# HISTORIC AND DESIGN REVIEW COMMISSION

August 19, 2020

**HDRC CASE NO:** 2020-339  
**ADDRESS:** 725 E GUENTHER ST  
**LEGAL DESCRIPTION:** NCB 2882 BLK 7 LOT E IRR 124.4 FT OF 7  
**ZONING:** RM-4,H  
**CITY COUNCIL DIST.:** 1  
**DISTRICT:** King William Historic District  
**APPLICANT:** MICHAEL LOCKWOOD  
**OWNER:** Bob Lord  
**TYPE OF WORK:** Exterior alterations, rehabilitation, window replacement, site modifications  
**APPLICATION RECEIVED:** July 24, 2020  
**60-DAY REVIEW:** Not applicable due to City Council Emergency Orders  
**CASE MANAGER:** Stephanie Phillips

**EXISTING SITE PLAN**  
**PROPOSED SITE PLAN**

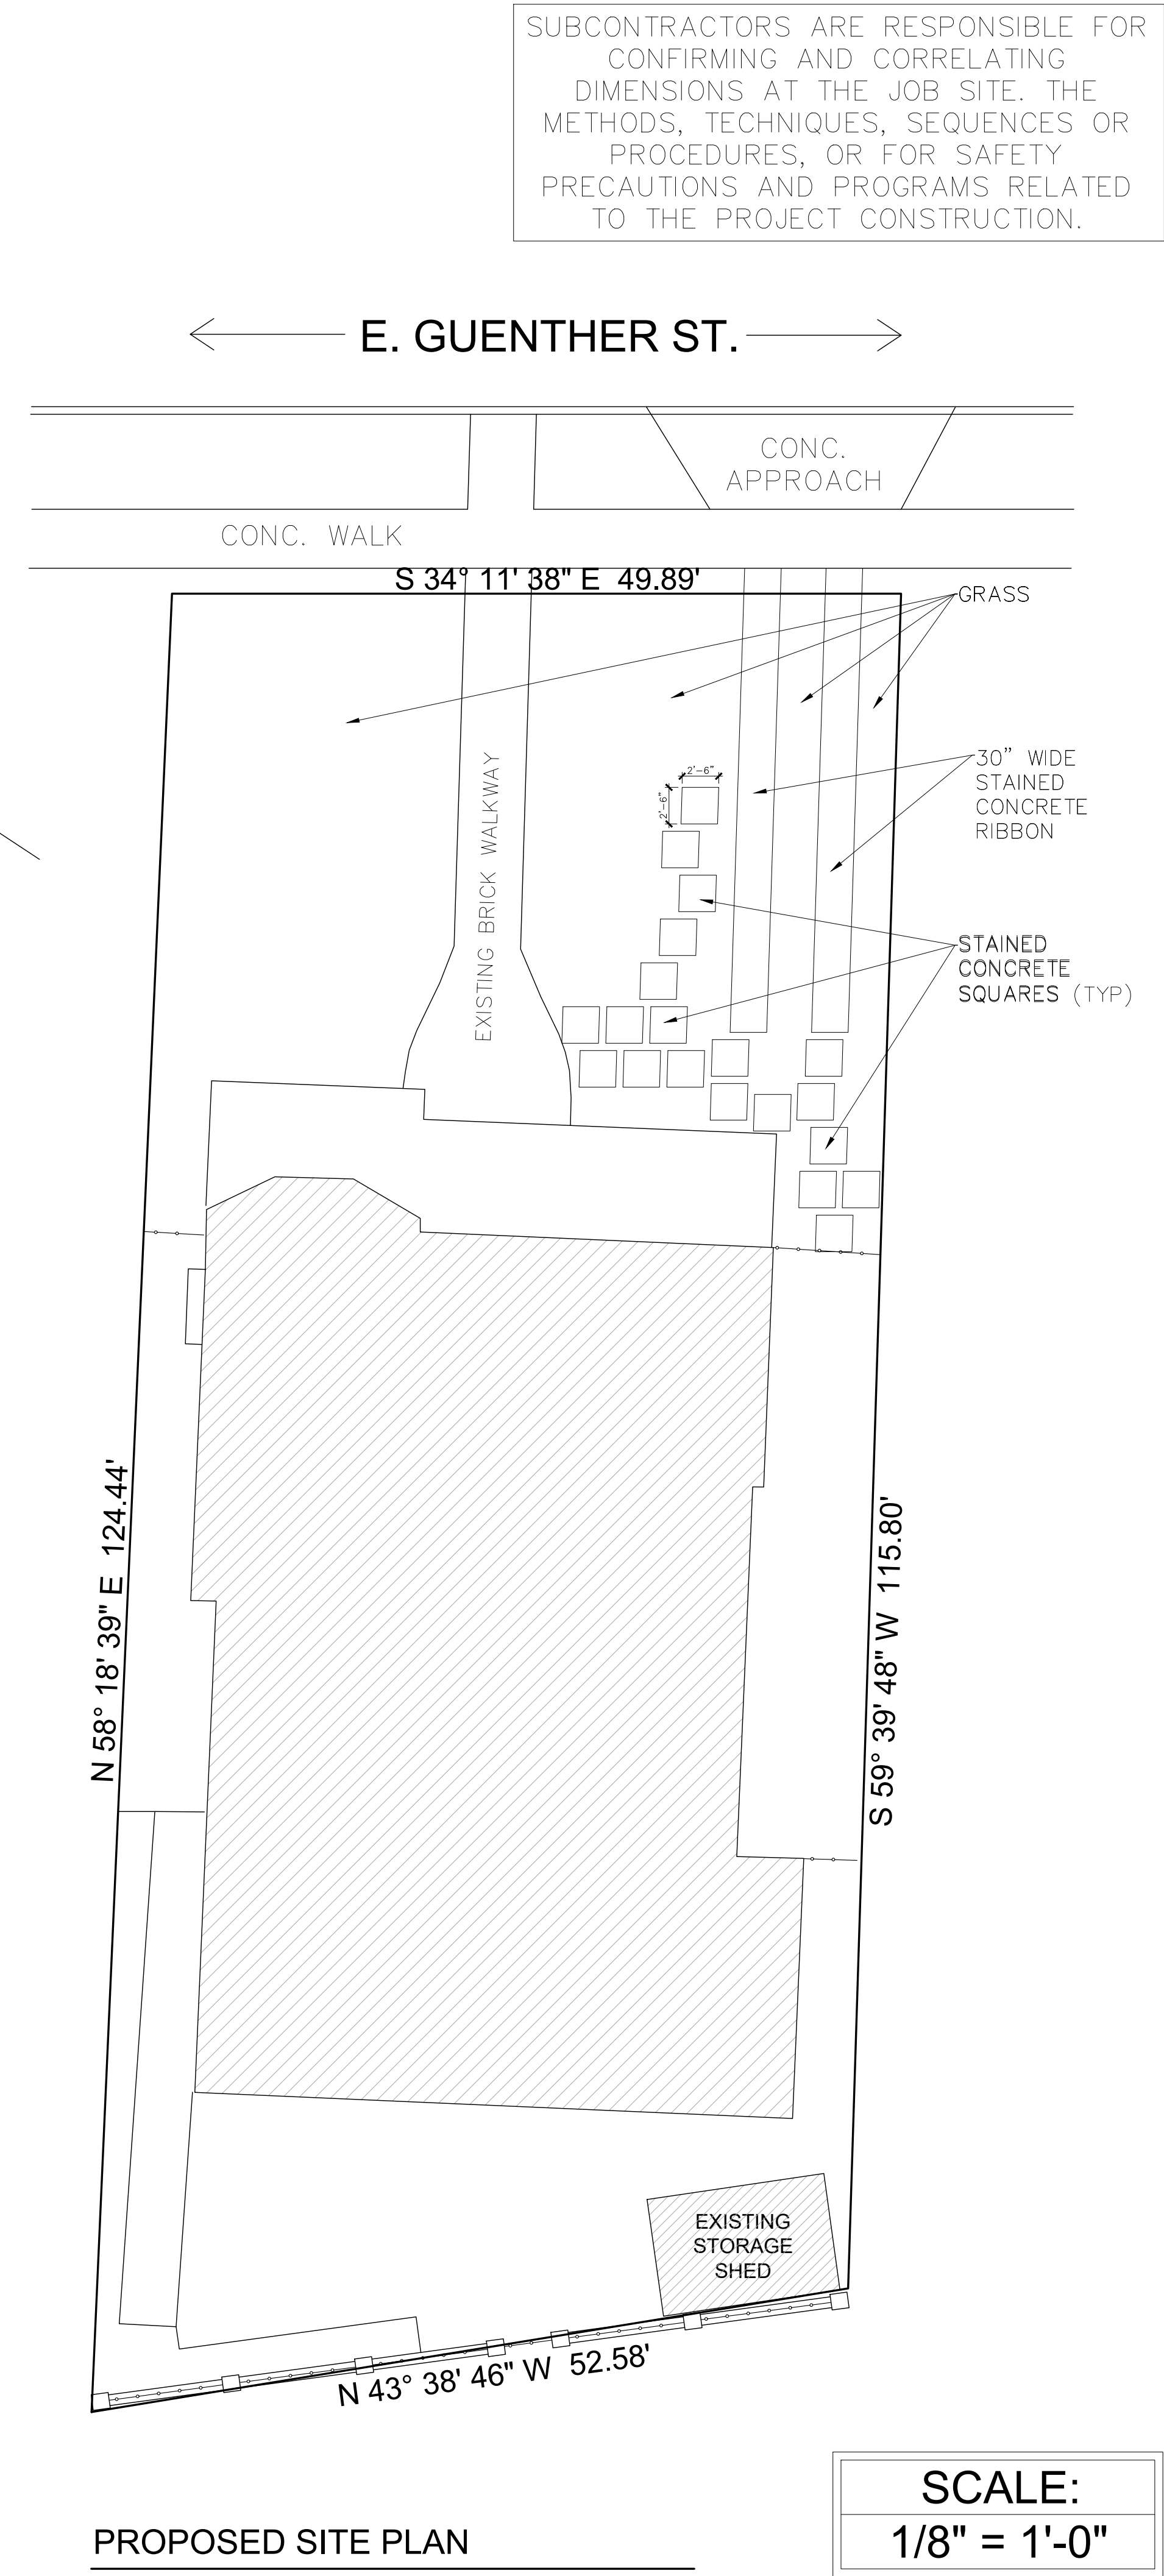
- e. RIBBON DRIVEWAY – The applicant has proposed to modify the existing concrete driveway to include two ribbons. Staff finds the request appropriate and to be an improvement to the existing conditions and finds that the maximum width of the driveway should be 10 feet to align with the applicable Guidelines for Site Elements.

- f. FRONT YARD HARDSCAPING – The applicant has proposed to install several stained concrete stairs in the front yard per the proposed site plan. According to the Guidelines, new hardscaping modifications in the front yard should be consistent with existing precedents in the district. Staff does not find the use of square pavers appropriate. Staff finds that a continuous concrete or decomposed granite walkway between the existing front walkway and the proposed ribbon driveway would be appropriate.

- i. That the driveway is no wider than 10 feet. An updated site plan with dimensions is required.

Item 5, Staff does not recommend approval of the installation of concrete squares in the front yard. Staff recommends that a continuous concrete or decomposed granite walkway between the existing walkway and driveway be proposed, which may be generally eligible for administrative approval.

**EXTERIOR ELEVATIONS**

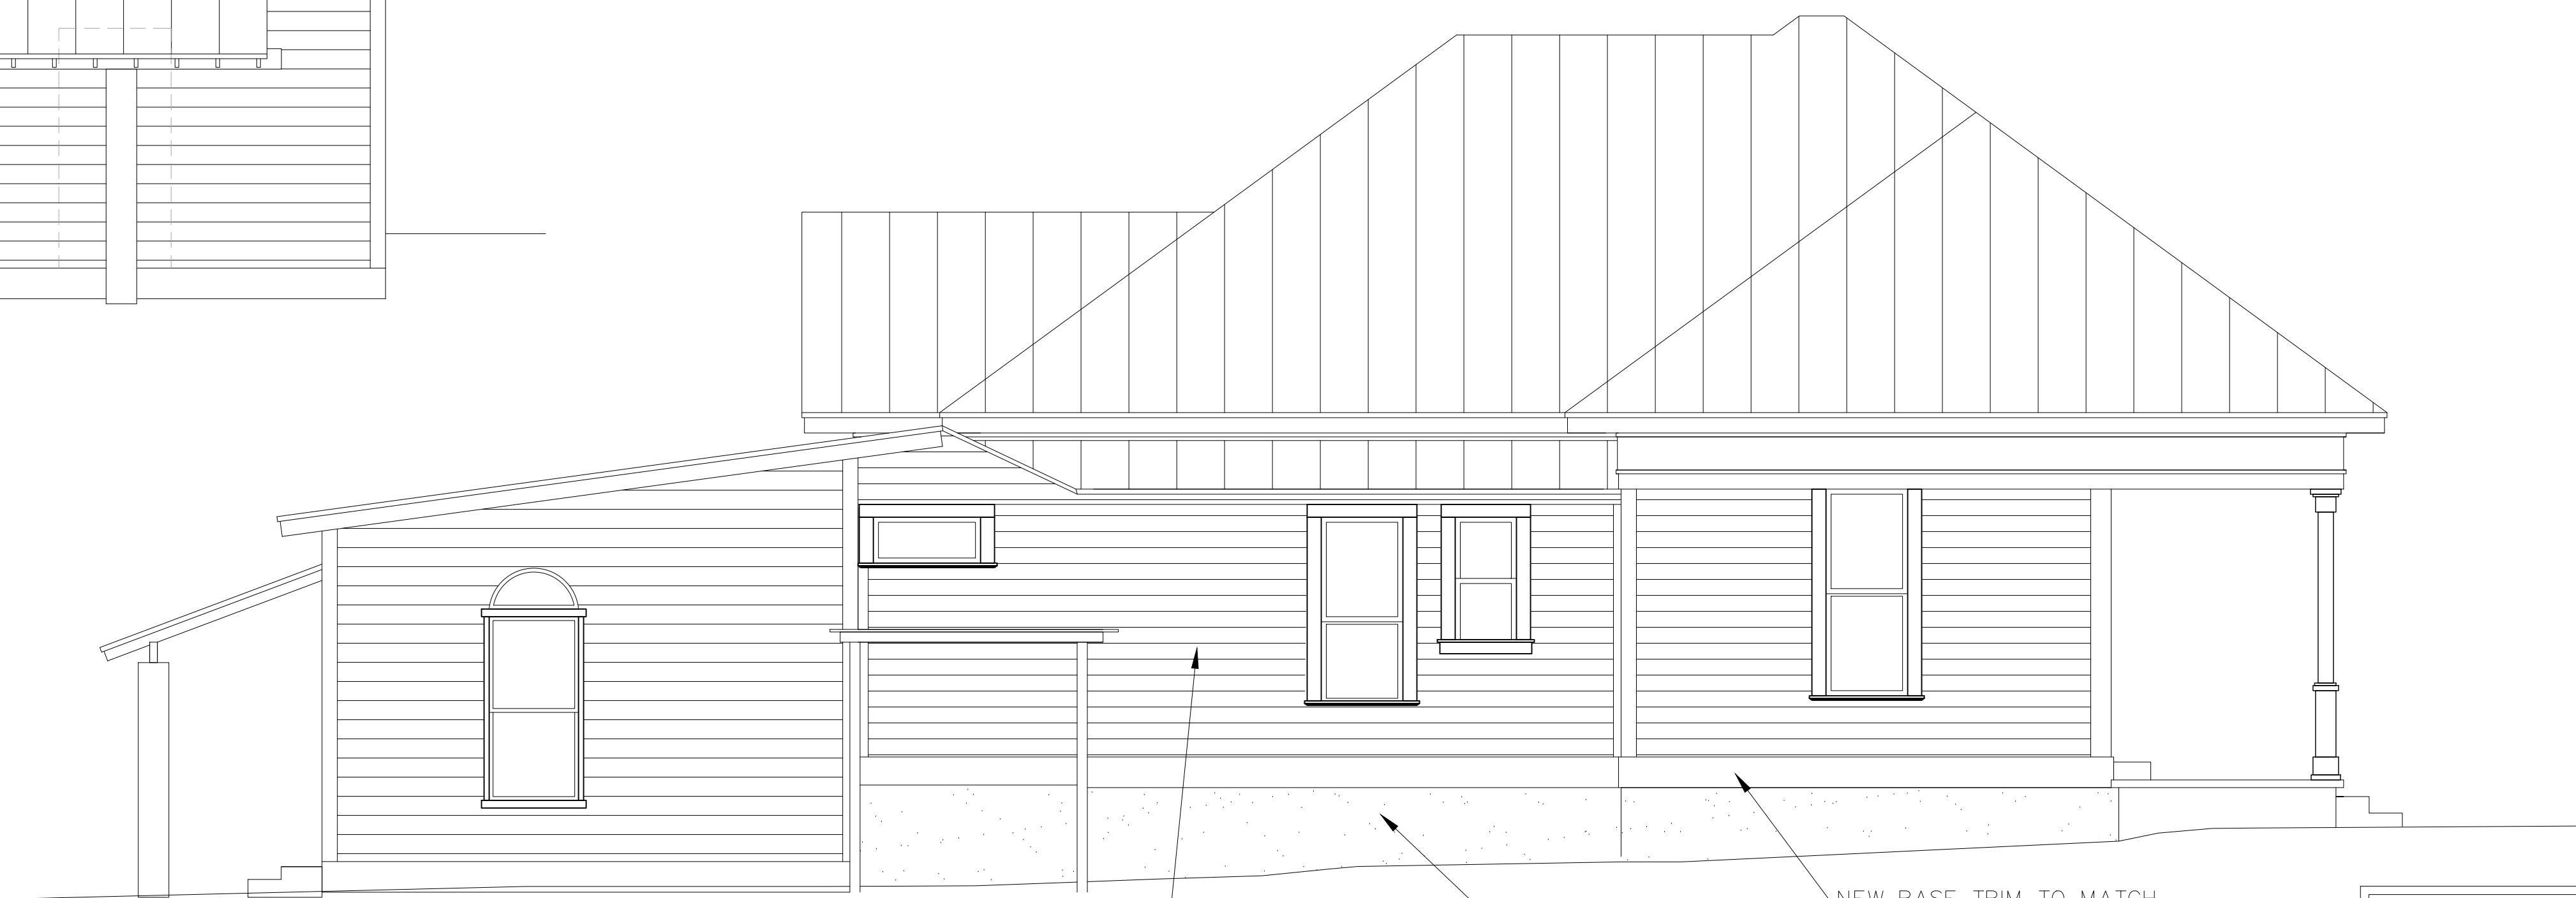
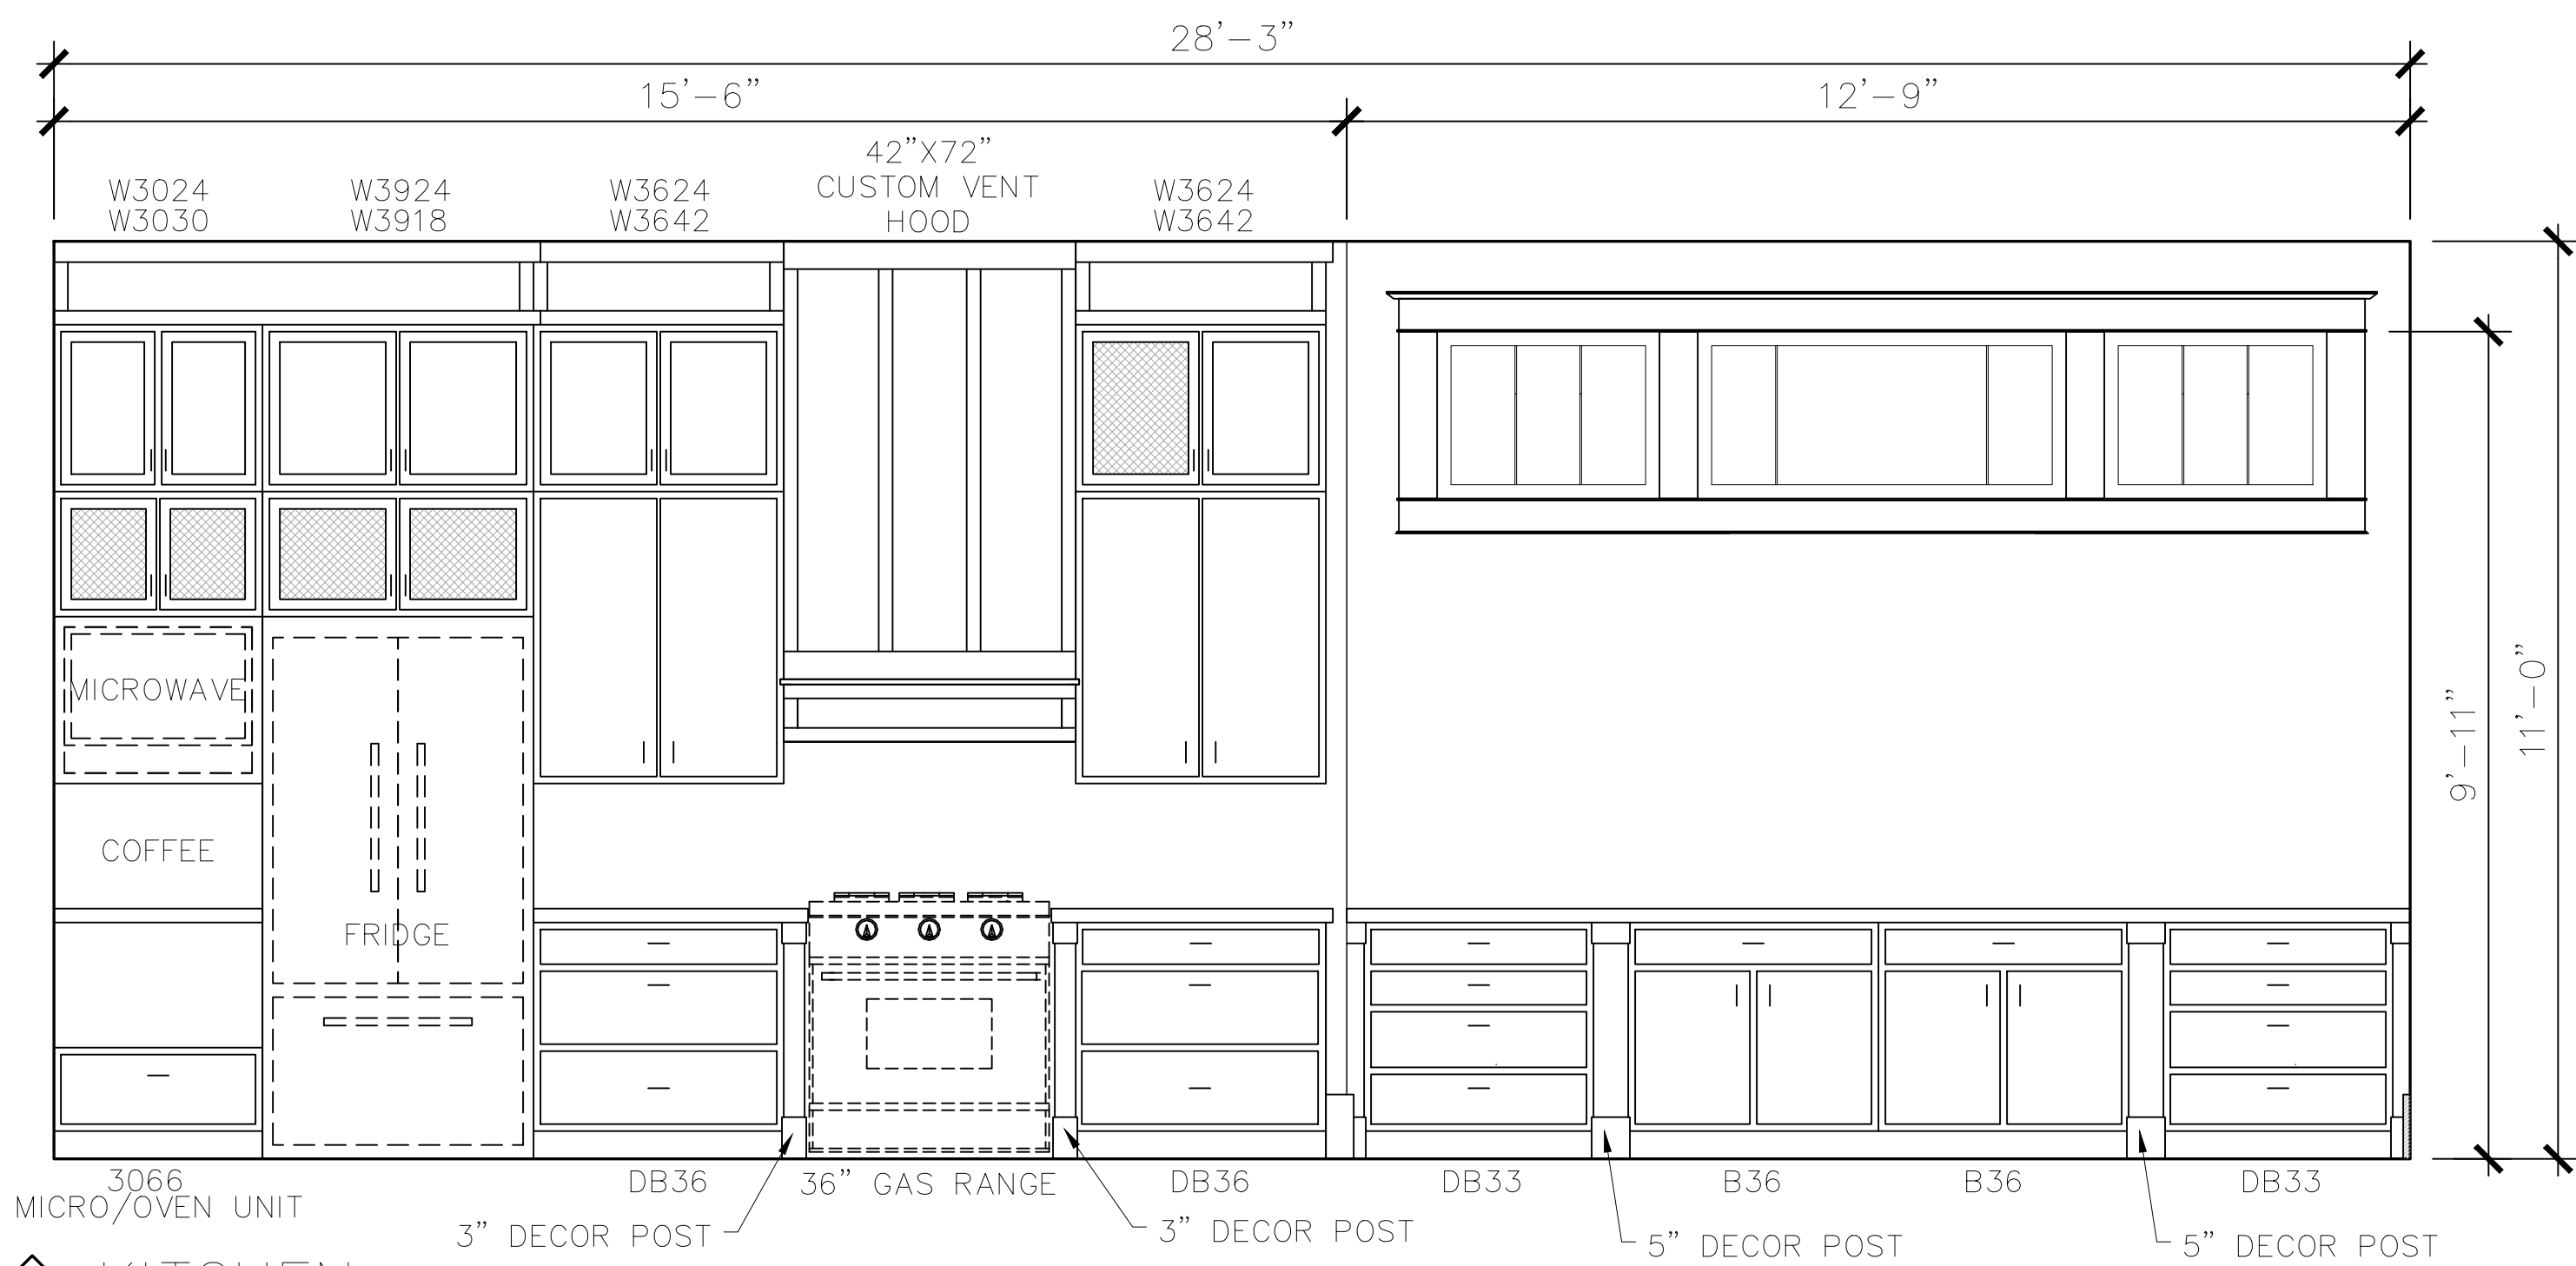
- b. WINDOW REPLACEMENT – The applicant has proposed to replace several non-original windows on the side of the structure. The windows are located in the portion of the home that features non-original stucco siding. The several of the new windows will feature a one over one configuration, and two will feature a horizontal clerestory configuration. The clerestory window proposed on the right elevation will feature a taller header height than the adjacent original windows. While staff finds the replacement of non-original windows generally appropriate, staff does not find the proposed configurations consistent at this time. Staff finds that the windows should feature a one over one configuration, be vertically oriented, and feature head and sill heights that generally align with existing original windows on the structure.

- c. WINDOW REMOVAL – The applicant has proposed to remove several non-original windows on the rear portion of the side elevations of the structure. While staff finds the proposal to be generally appropriate due to the existing conditions, staff finds that the applicant should incorporate a minimum of one window opening on

the rearmost portion of the right elevation to ensure that the Guidelines for siding-to-opening ratios are maintained.

Item 1, Staff recommends approval of the window replacement based on finding b with the following stipulations:

- i. That the proposed clerestory windows be modified to feature a one over one configuration, vertical orientation, and proportions and sill and header heights that are consistent with existing original windows on the structure as noted in finding b. The applicant is required to submit updated elevation drawings to staff for review and approval prior to the issuance of a Certificate of Appropriateness.

- ii. That the windows meet the following stipulations: windows must be fully wood or aluminum-clad wood windows and feature a true one-over-one configuration. Meeting rails must be no taller than 1.25” and stiles no wider than 2.25”. White manufacturer’s color is not allowed, and color selection must be presented to staff. There should be a minimum of two inches in depth between the front face of the window trim and the front face of the top window sash. This must be accomplished by recessing the window sufficiently within the opening or with the installation of additional window trim to add thickness. Window trim must feature traditional dimensions and architecturally appropriate sill detail. Window track components must be painted to match the window trim or concealed by a wood window screen set within the opening.

Item 2, Staff recommends approval of the window removal based on finding c with the following stipulation:

- i. That the applicant retains or installs a window on the rear portion of the right elevation as noted in finding c. The applicant is required to submit updated elevation drawings to staff for review and approval prior to the issuance of a Certificate of Appropriateness.

- ii. That the window meets the following stipulations: windows must be fully wood or aluminum-clad wood windows and feature a true one-over-one configuration. Meeting rails must be no taller than 1.25” and stiles no wider than 2.25”. White manufacturer’s color is not allowed, and color selection must be presented to staff. There should be a minimum of two inches in depth between the front face of the window trim and the front face of the top window sash. This must be accomplished by recessing the window sufficiently within the opening or with the installation of additional window trim to add thickness. Window trim must feature traditional dimensions and architecturally appropriate sill detail. Window track components must be painted to match the window trim or concealed by a wood window screen set within the opening.
